4777.01 - 354 Barkham Road, Wokingham RG41 4DE

DESIGN SUMMARY REPORT

PROJECT NUMBER: 4777			DOCUMENT REF: 4777-DFL-HLG-XX-RP-EO-13001			
S3	P02	Second Issue	AC	AE	AE	03/07/2026
S3	P01	First Issue	AC	AE	AE	22/06/2026
Suitability	Revision	Purpose Description	Originated	Checked	Approved	Date

Figure 3: Surveyed Bat Flight Paths

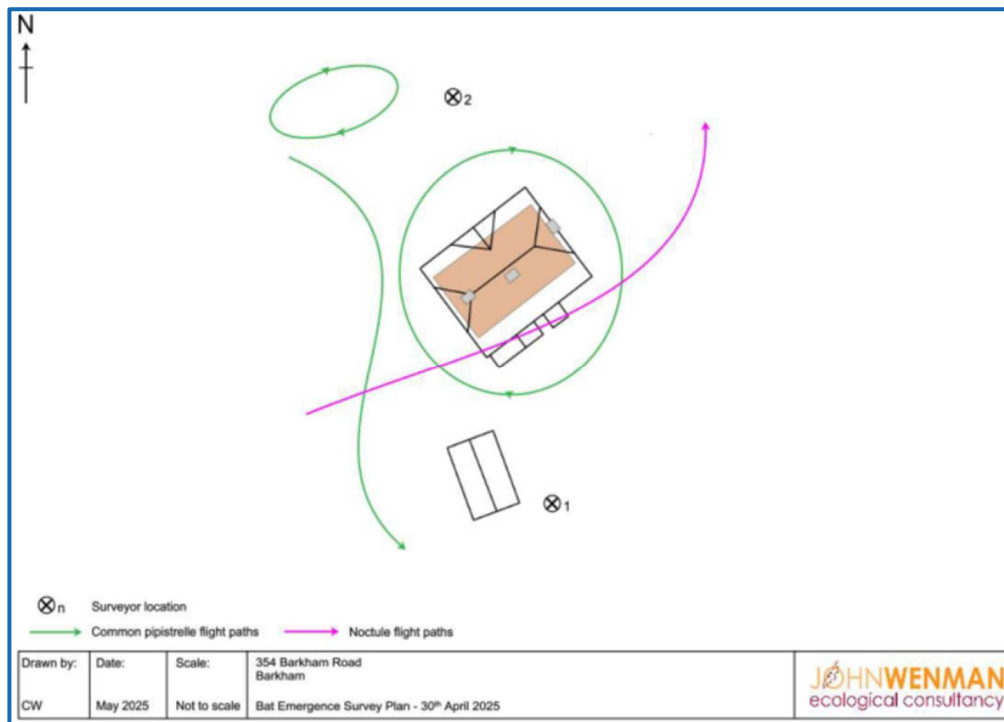
- 6.3.3. *The Architect has not taken account of the bat roost recorded to the north, the proximity to the Oak T5 and the need to retain dark corridors for bats and wildlife. The plan does not demonstrate that a second wall light installed as a downlight is necessary for health and safety. I request that the light on the east of the front door is omitted unless contour plans are provided to demonstrate this would not impact the dark corridor and foraging in the Oak canopy. I request that the light proposed on the east side elevation is reconsidered*

- 8.1.2. Concerns have been raised by Wokingham Borough Council regarding a bat roost which has been identified close to oak tree T5 and the need to retain dark corridors for the bats and wildlife. There is also concern for light spill on the boundary vegetation.
- 8.1.3. It has been assumed based on the available topographic view, that the areas to surrounding the proposed development are likely to be ecologically sensitive. The visual location of these areas can be seen in **Appendix 1 – Sensitive Receptors**.

- 11.2.2. In response to **6.3.3**, A vertical illuminance grid (**PSER 004** on calculation **4777-DFL-ELG-XX-CA-EO-13001**) has been calculated demonstrating that vertical light spill does not exceed 0.40 lux as per GN08.2023 guidance, onto Oak T5. With this in mind, the light on the east side of the front door has not been omitted.
